**EL PASO COUNTY PLANNING AND
 COMMUNITY DEVELOPMENT
 DEPARTMENT**

CONSTRUCTION DRAWINGS CHECKLIST

OUTLOOK POWERS & GRINNELL

CIVIL CONSTRUCTION PLANS

OUTLOOK POWERS & GRINNELL
 BYPASS STORM LINE PLAN & PROFILE

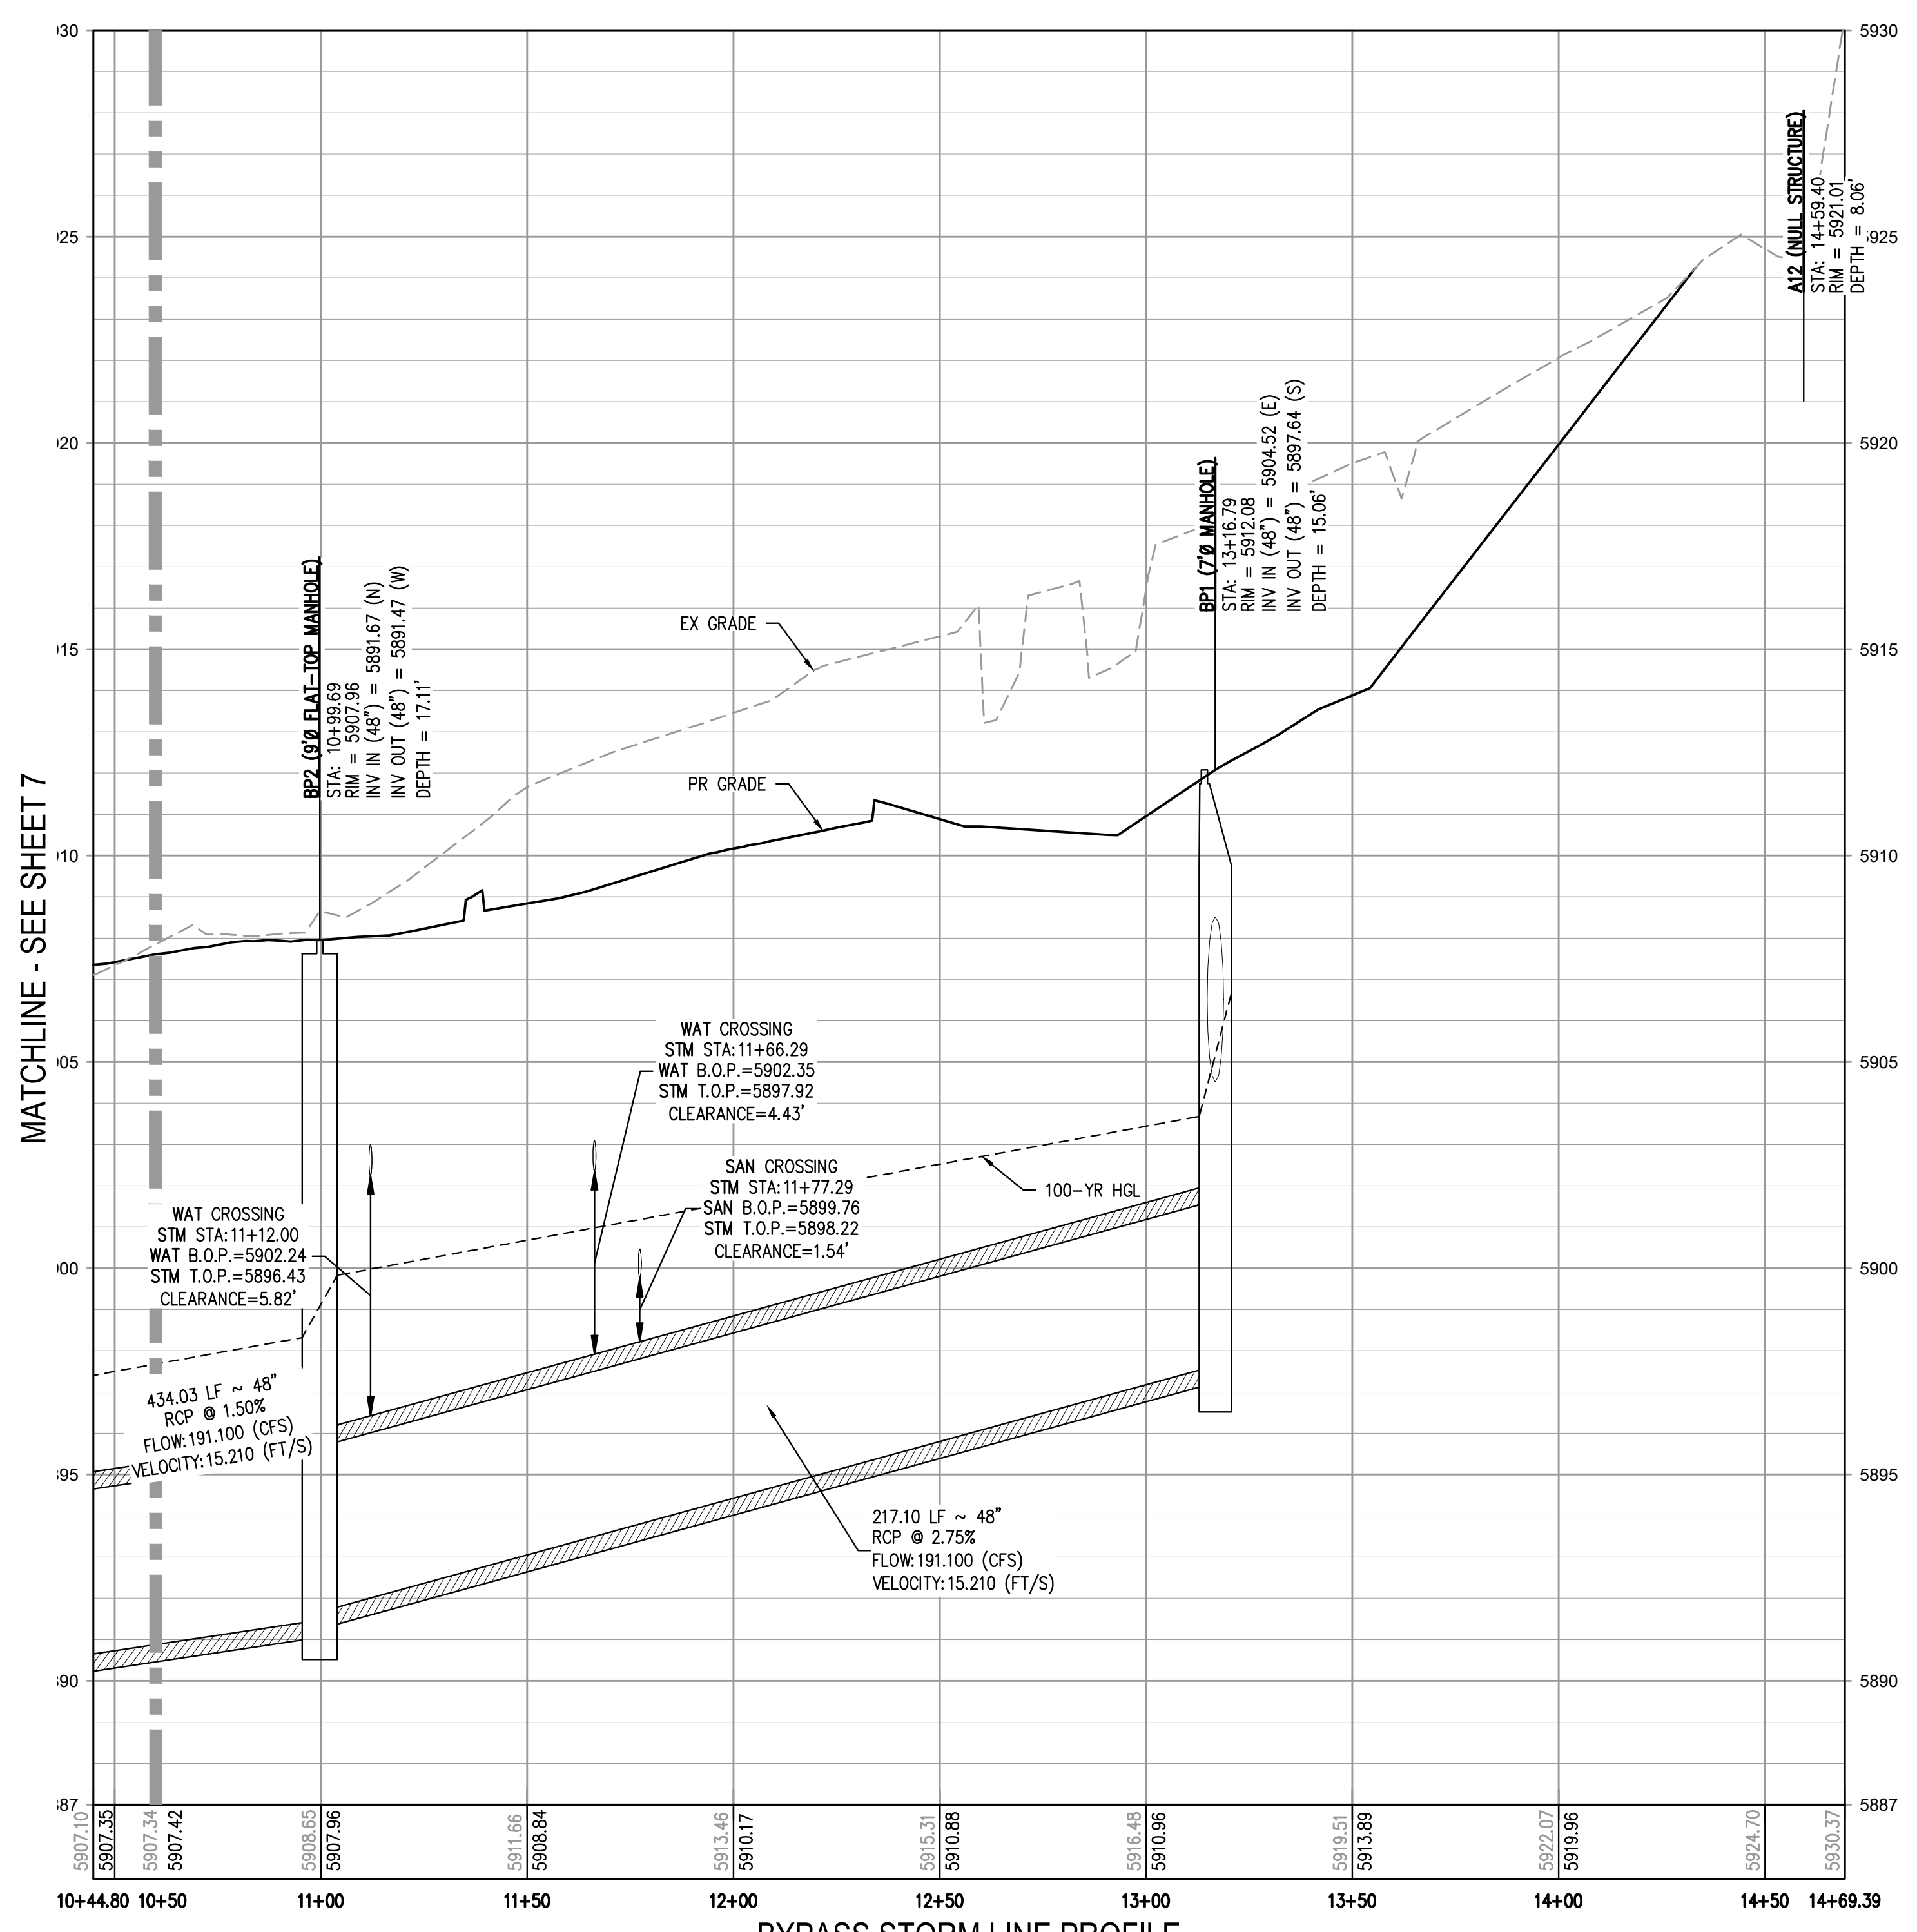
Label roadway and show ROW lines

Provide structure details on how this is being converted to connect the stormdrain to the box culvert.

Extend Profile to include this pipe segment.

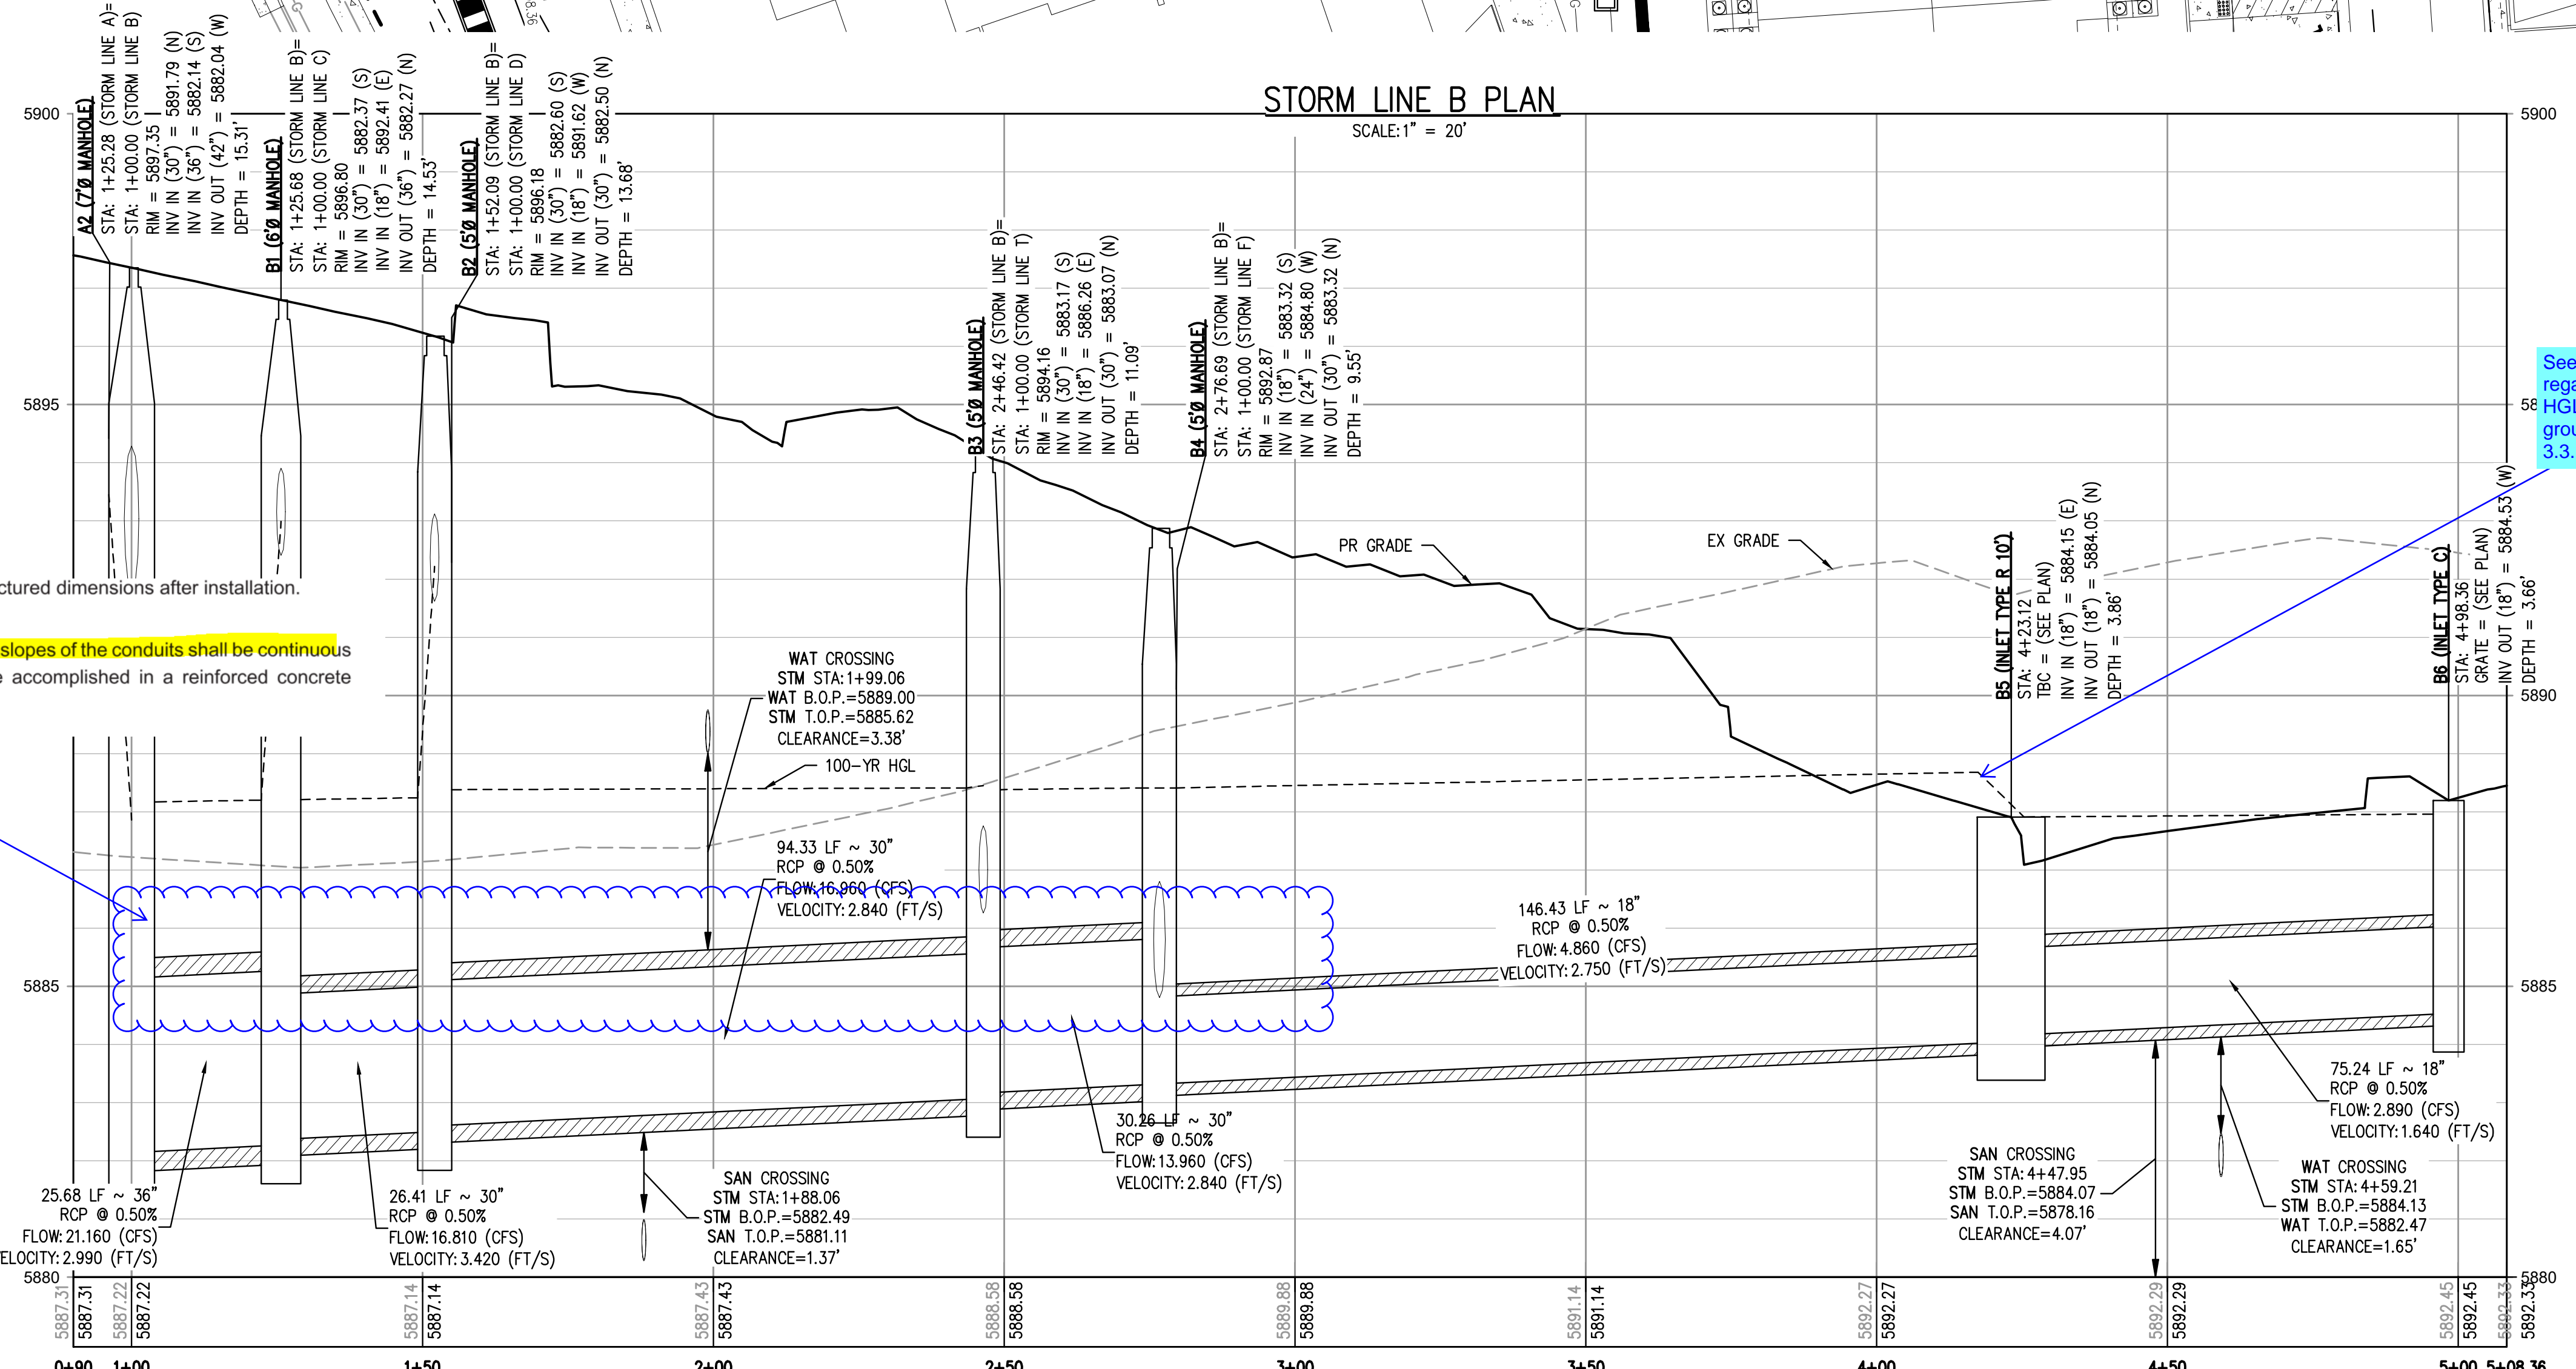
Rotate the plan view 180 to match the profile.

See comment provided in sheet 7 regarding the HGL. Additionally the HGL must be at or below the proposed ground surface per ECM Section 3.3.1.C

59 OF 60

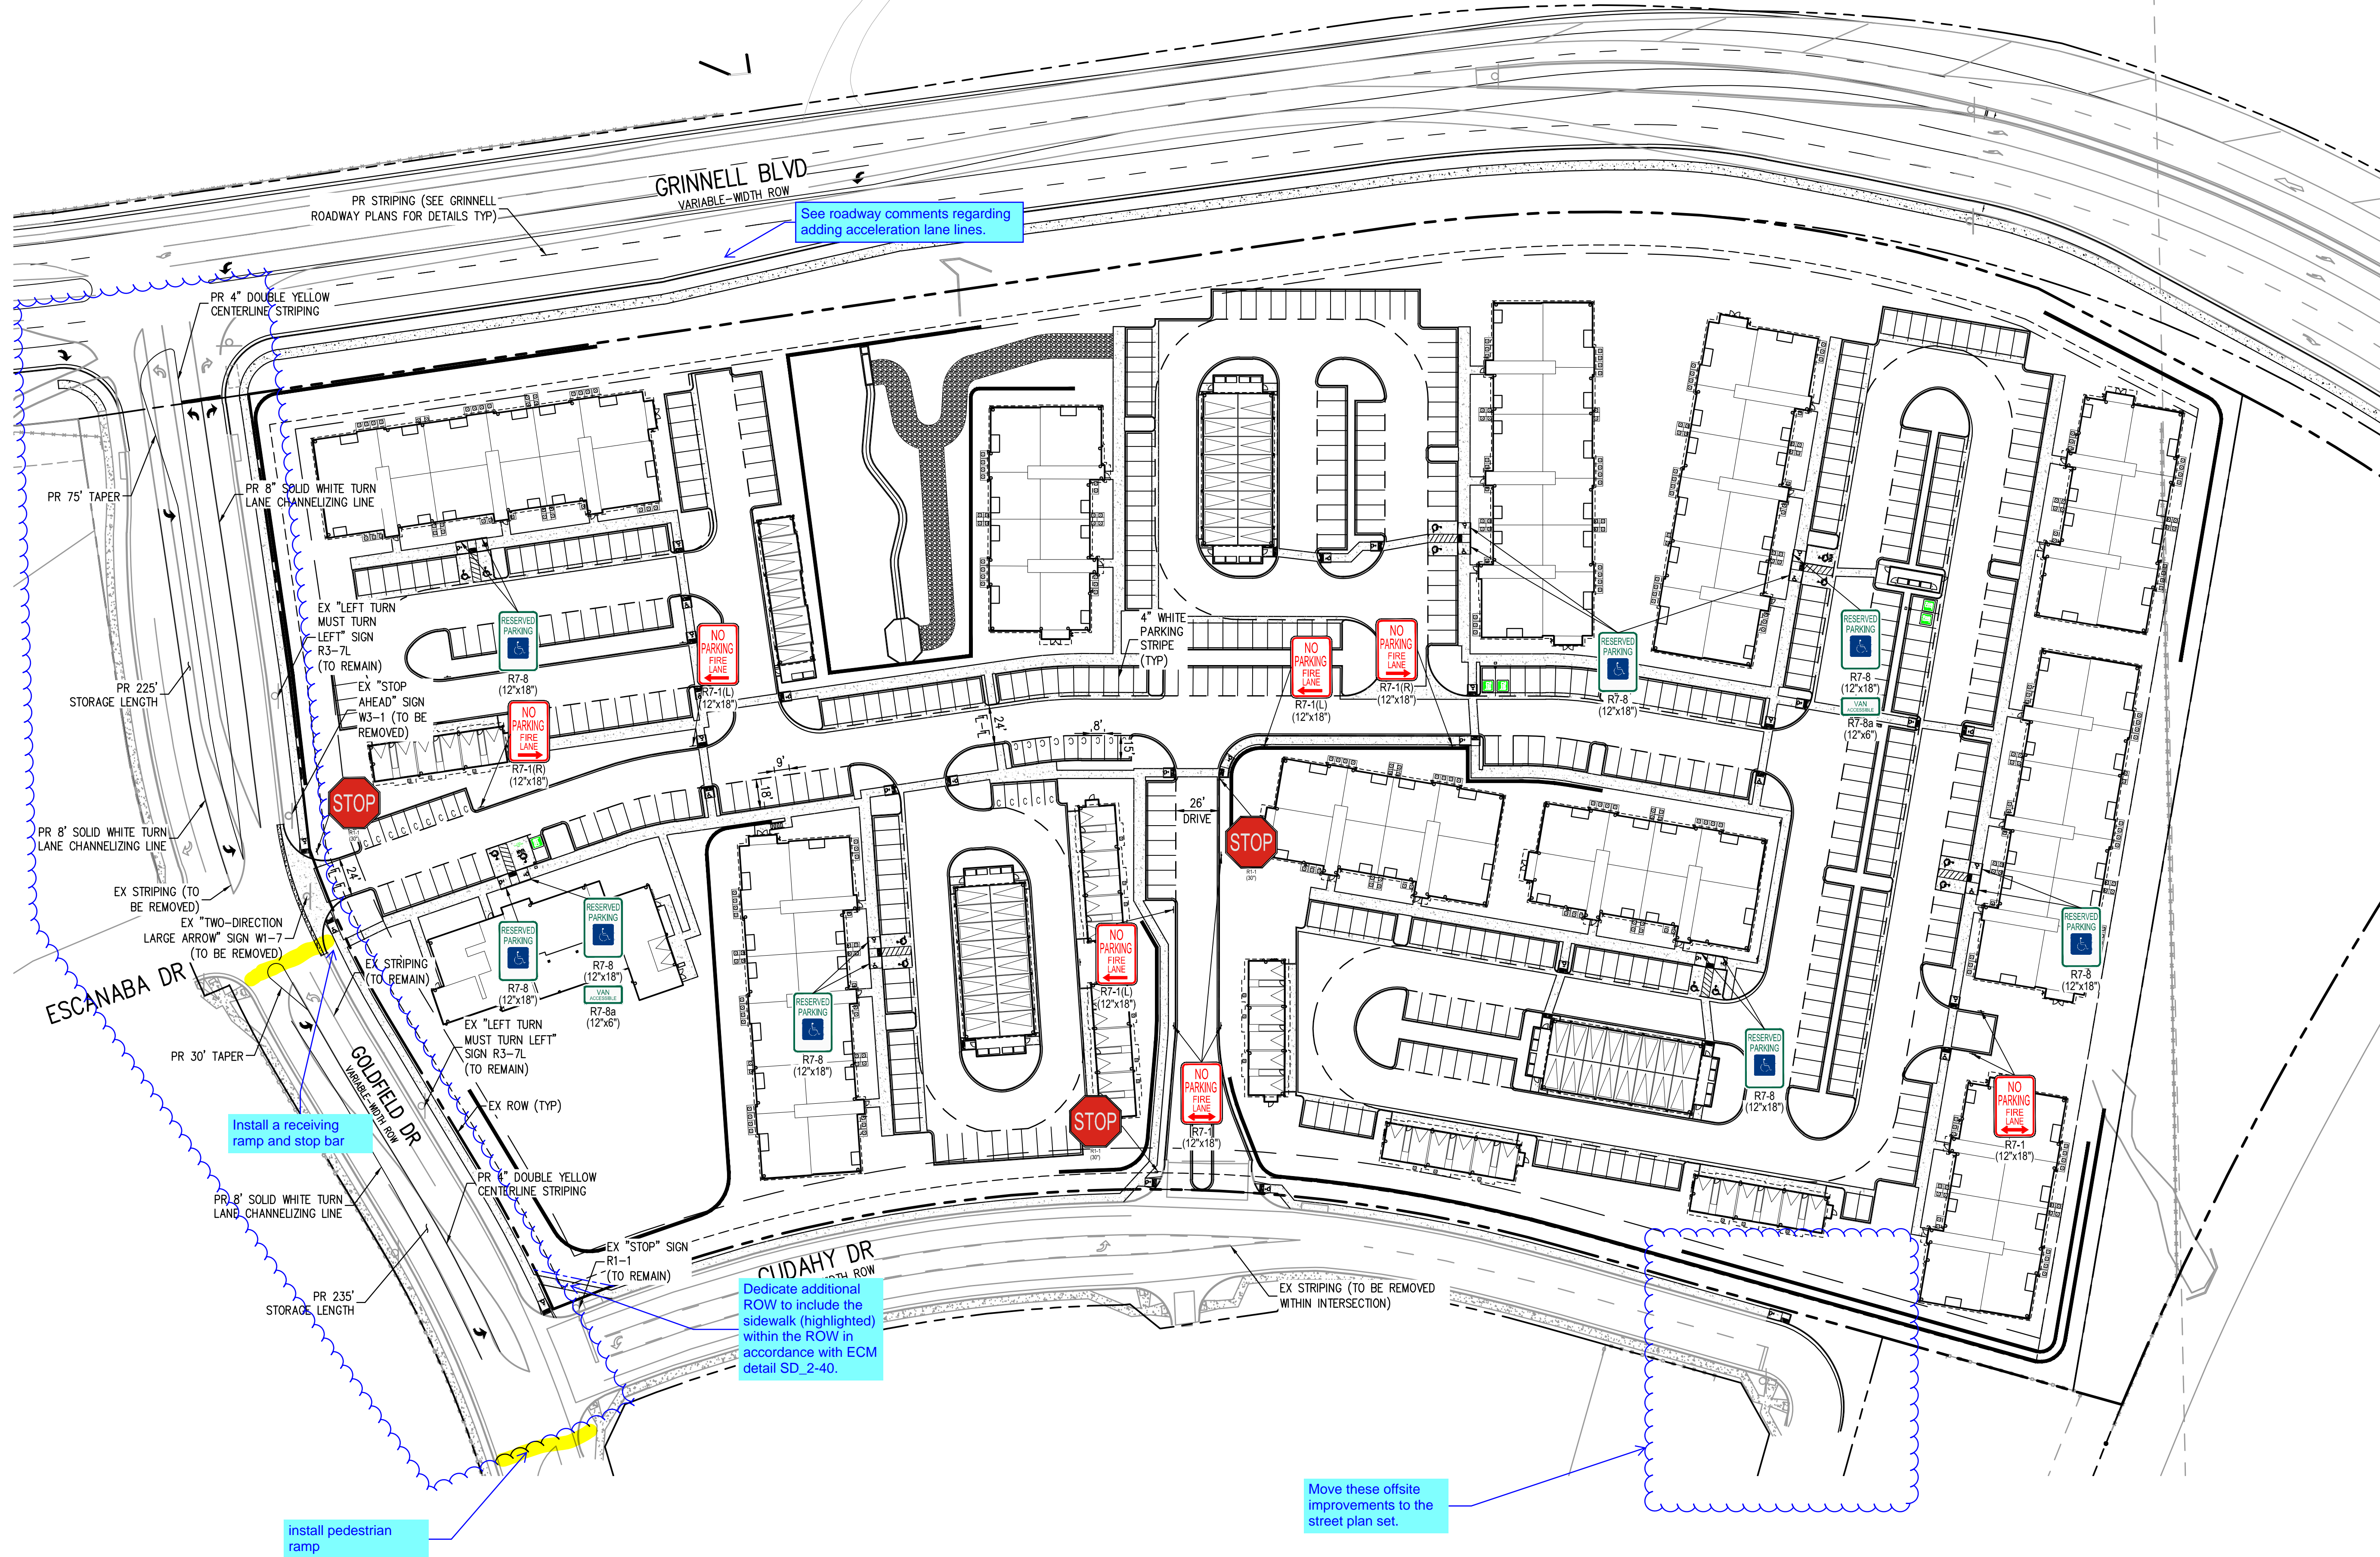
See roadway comments regarding adding acceleration lane lines.
